METROPOLITAN GOVERNMENT OF NASHVILLE AND DAVIDSON COUNTY

STAFF RECOMMENDATION
3641 Richland Avenue
Lot 4, Richland Hall Development
August 17, 2016

Application: New construction—infill and outbuilding; Setback determination
District: Richland-West End Neighborhood Conservation Zoning Overlay
Council District: 24
Map and Parcel Number: 10409028300
Applicant: Chad Gore, Mike Ford Builders
Project Lead: Melissa Baldock, melissa.baldock@nashville.gov

2 LEFT ELEVATION
1/8" = 1'-0"

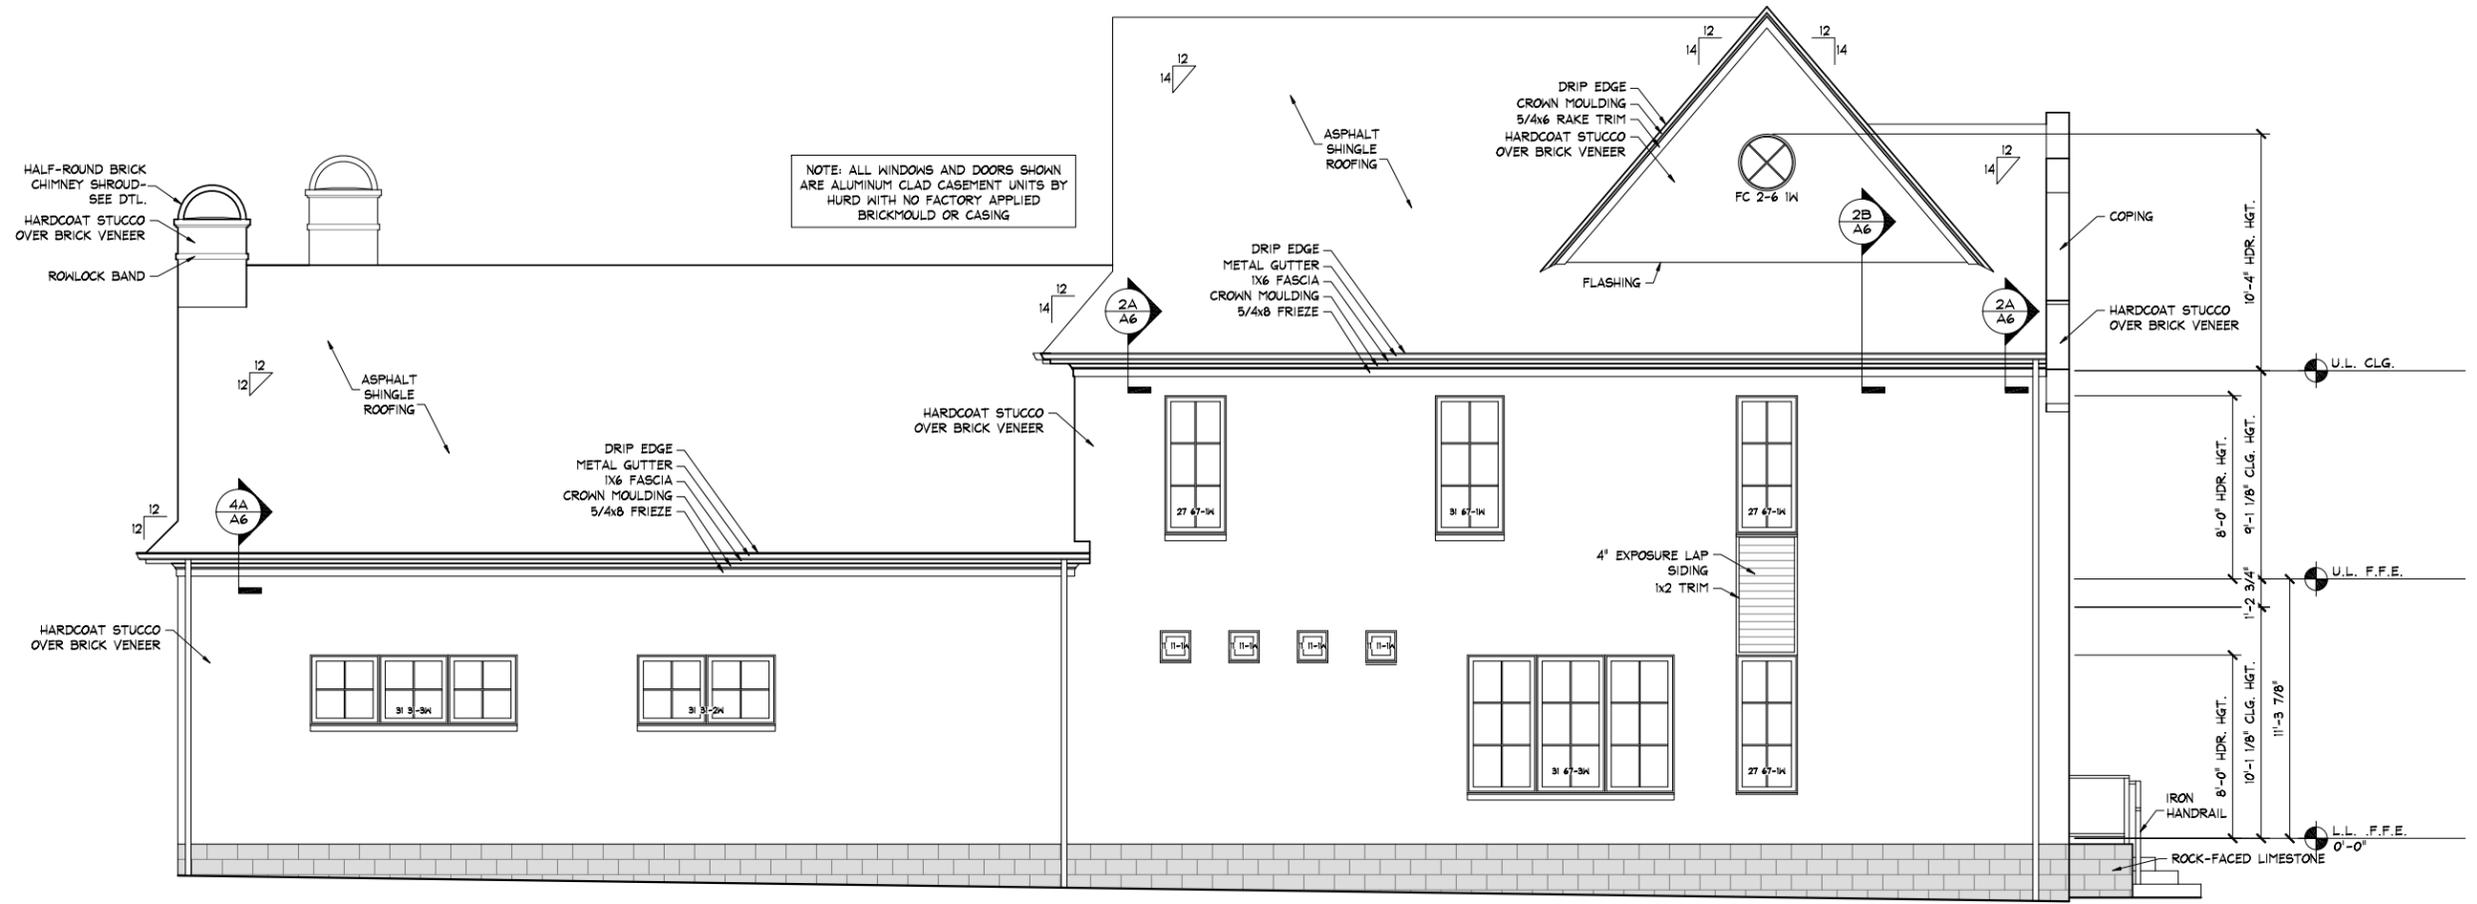
*On the left elevation are four small window openings that are approximately one foot by one foot (1' X 1'). The design guidelines state that window openings should be a minimum of four square feet (4 sq. ft.). Staff therefore recommends that these window openings be enlarged to be a minimum of four square feet (4 sq.ft.)

1. The finished floor height be consistent with the finished floor heights of neighboring historic houses, to be verified by MHZC staff in the field;
2. Staff approve the masonry samples prior to purchase and installation;
3. Staff approve the asphalt shingle color and texture;
4. Staff approve all window and door selections prior to purchase and installation; and
5. The one foot by one foot (1' X 1') window openings on the left elevation be a minimum of four square feet (4 sq. ft.)

With the enlargement of the window openings on the left elevation, staff finds that the infill's proportion and rhythm of openings meet Section II.B.1.g. of the design guidelines.

4 GARAGE LEFT ELEVATION
1/8" = 1'-0"

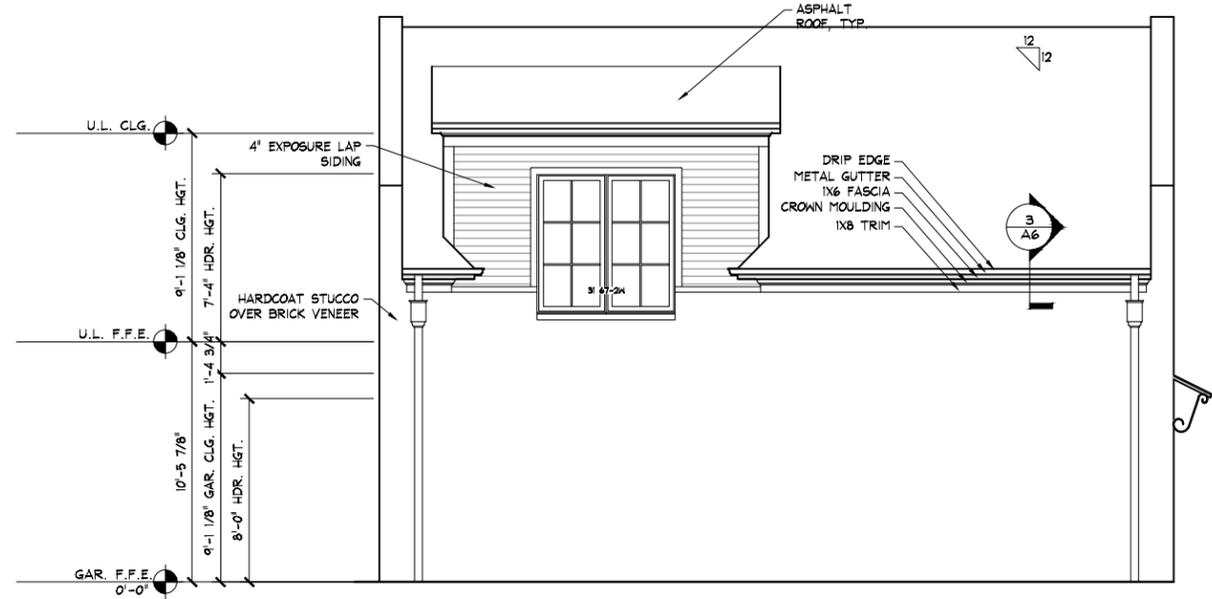
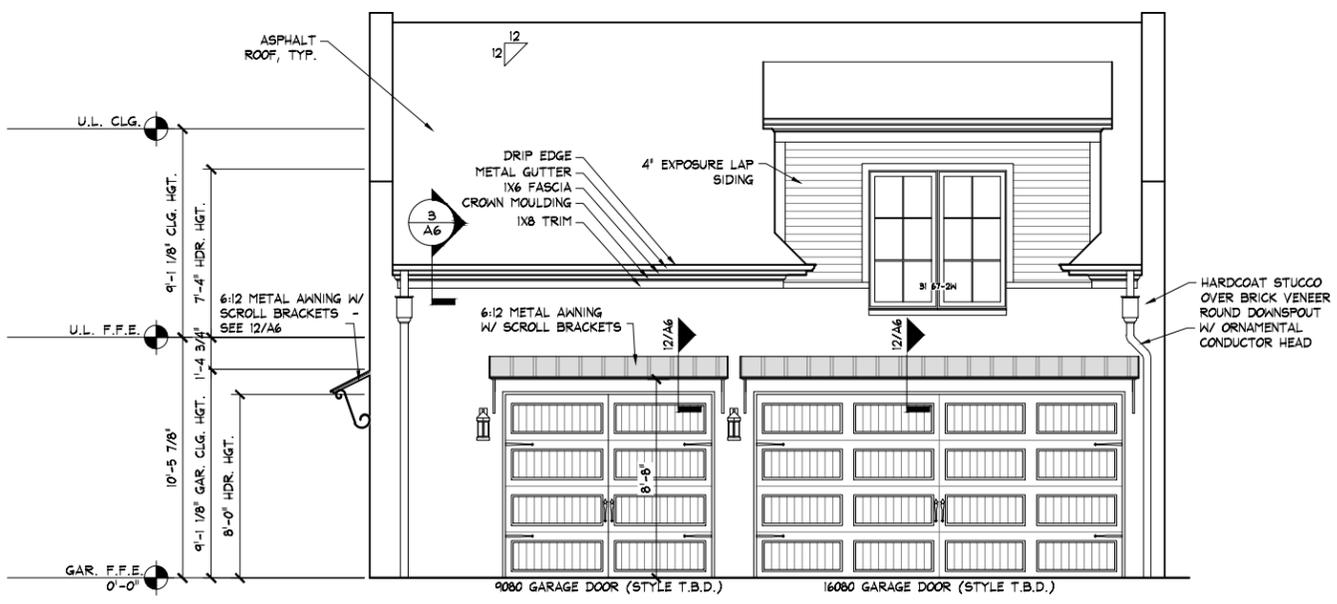
The proposed outbuilding has wall dormers on the two side elevations. Staff typically discourages wall dormers, but staff finds them to be appropriate on this structure for several reasons. The wall dormers will at most be minimally visible because they will be so far back from the front of the street. In addition, the dormers have widths that are modestly scaled so they are less than half the width of the wall below. Lastly, the dormers are set well off the ridge of the roof, which will help to reduce their scale.
